SHOREHAM NUCLEAR POWER STATION

SNRC-575

Equipment Dynamic Qualification - Supplemental Information
SER Outstanding Issue No. 8
Shoreham Nuclear Power Station - Unit 1
Docket No. 50-322

PRESSURE TRANSMITTER (IC 61*PT 006) @ EL. 79'
FUNDAMENTAL FREQUENCY CALCULATION

WALL-MOUNTED STAND WITH 1CG1*PT006 INST.
 NOT TO SCALE

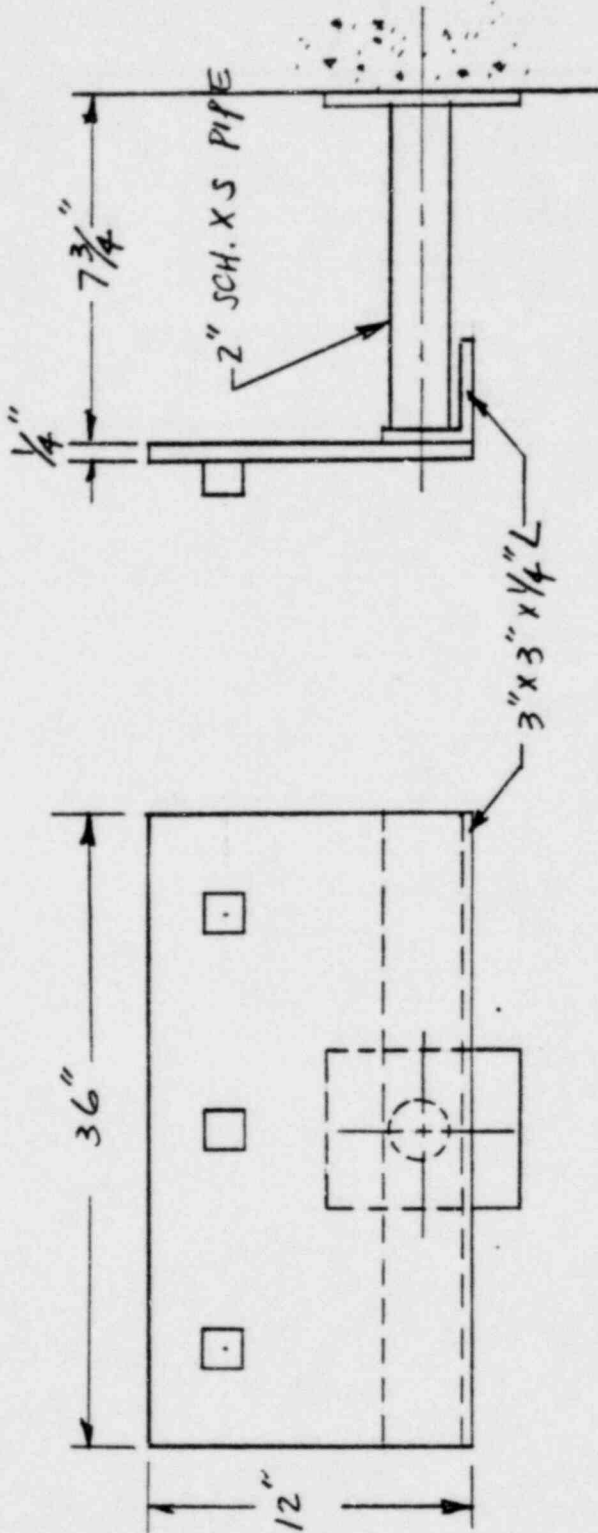
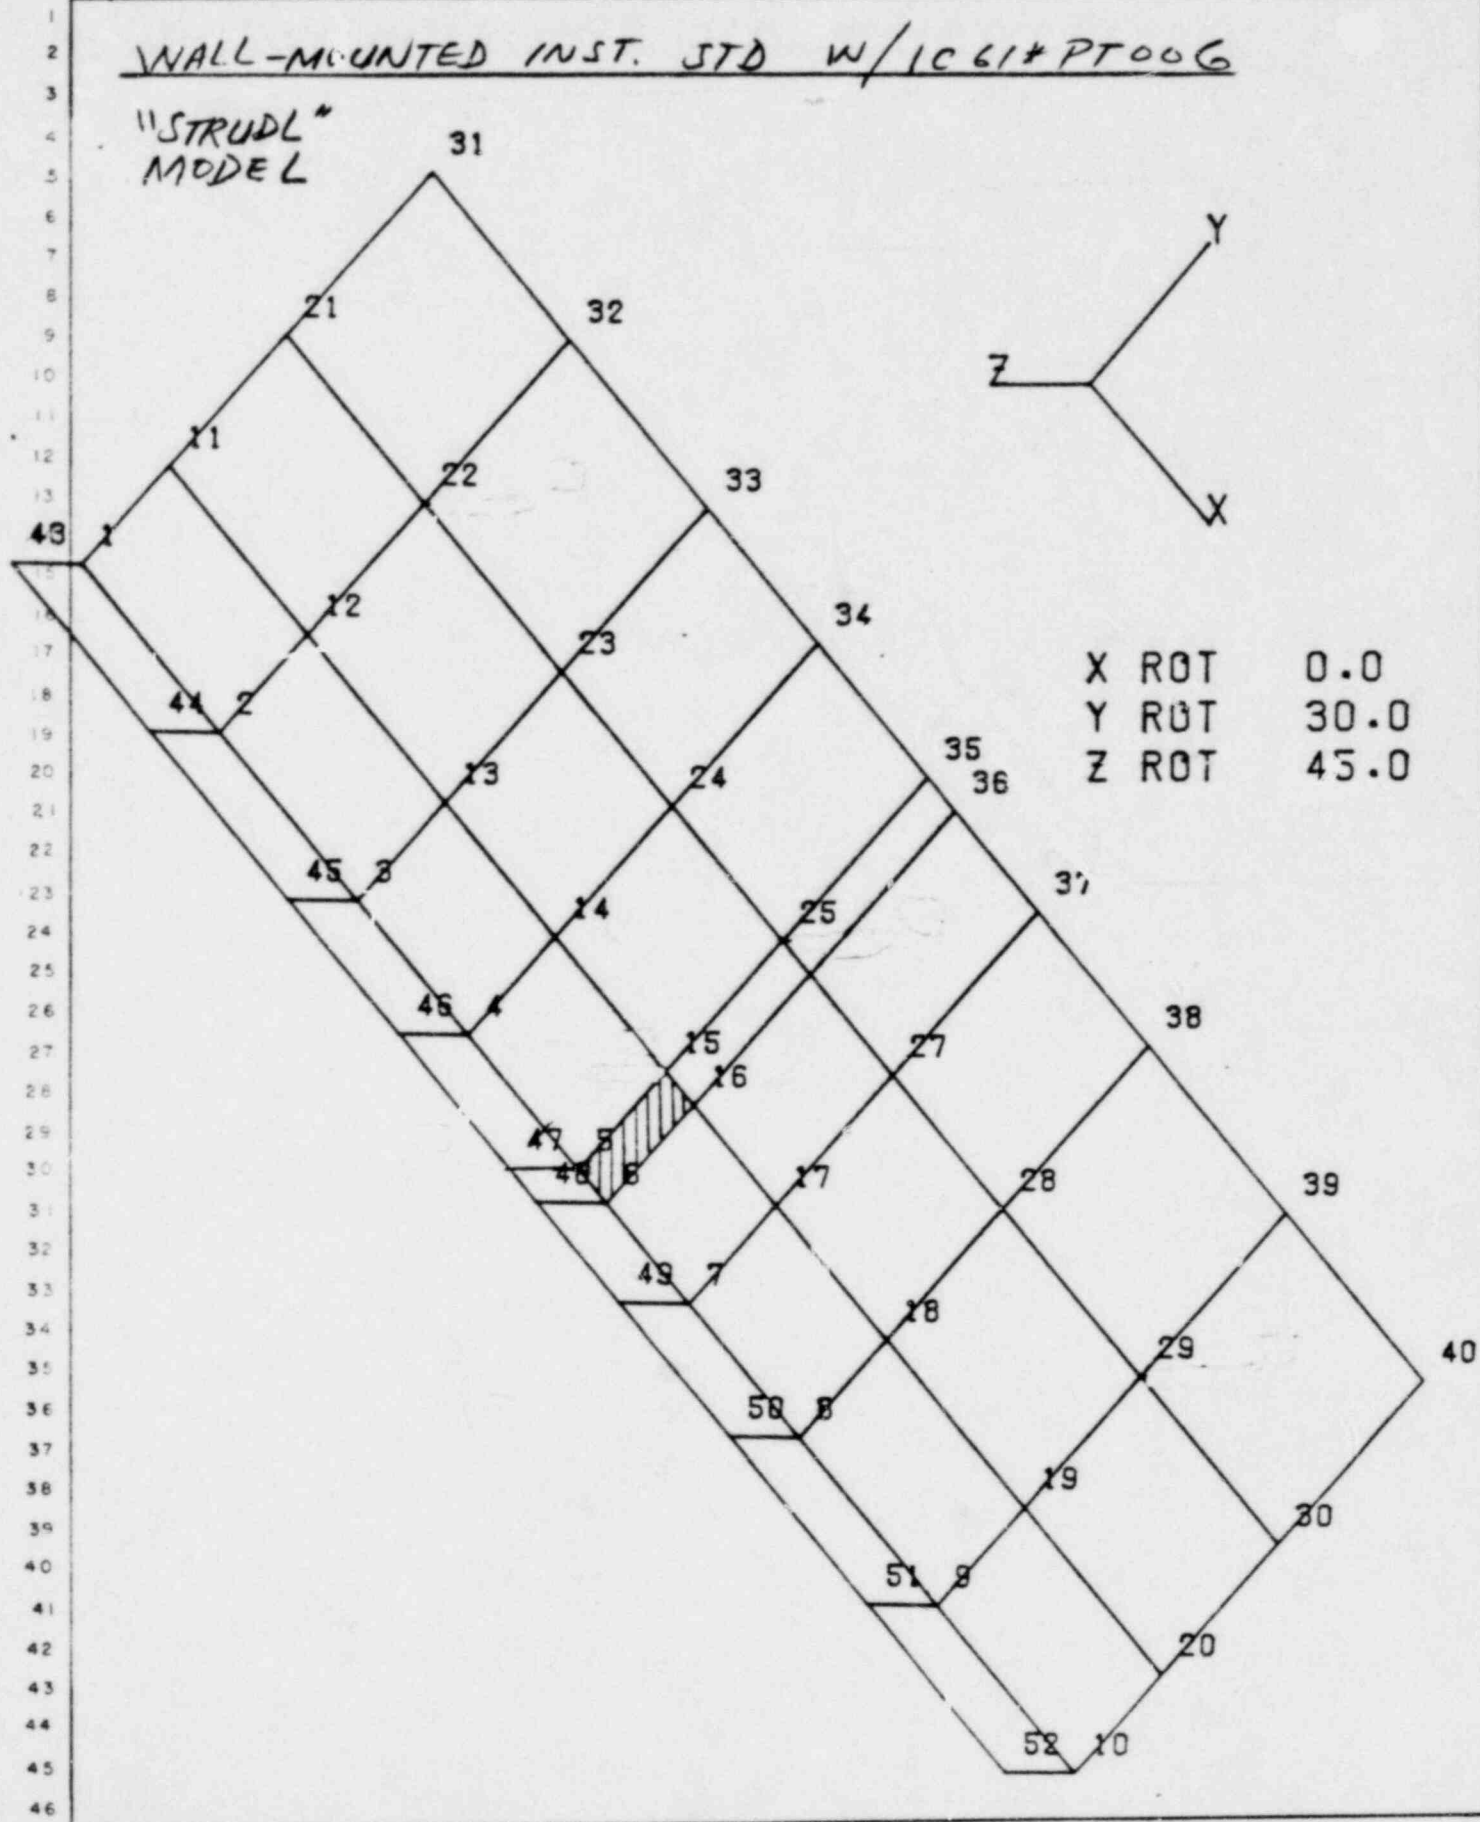
- a) Provide a calculation of support frame frequency by Stone & Webster.

1. ANALYSES HAVE BEEN PERFORMED TO CALCULATE THE FUNDAMENTAL FREQUENCY OF THE WALL-MOUNTED INSTRUMENT STAND WITH PRESSURE TRANSMITTER IC 61*PT 006. HAND CALCULATIONS WERE USED TO CALCULATE THE FREQUENCIES OF THE SUPPORT BEAM BENDING AND TORSIONAL MODES. A "STRU DL" FINITE ELEMENT MODEL WAS USED TO DETERMINE THE LOWER FREQUENCY FLEXURAL MODES OF THE PLATE.
2. A SKETCH OF THIS STAND IS SHOWN ON PAGE 2. ITS "STRU DL" MODEL IS SHOWN ON PAGE 3. THE 2" SCH. XS PIPE IS "RIGID" (150 HZ BENDING FREQUENCY) AND IS THEREFORE REPRESENTED BY SIMPLY SUPPORTING THE SHADED ELEMENT.
3. RESULT : FUNDAMENTAL FREQUENCY = 40 HZ, ASSOCIATED WITH A LOCAL PLATE BENDING MODE.

- a) A dynamic analysis was conducted to determine the support frame frequency of this stand with instruments attached, and is provided in Enclosure 1 to LLL30 letter SNRC-575. Results demonstrate a fundamental frequency of 40 Hz which is above the 5 Hz requirement to limit the dynamic loads on the mounted instruments to less than or equal to 2 g horizontal and 1.5 g vertical.
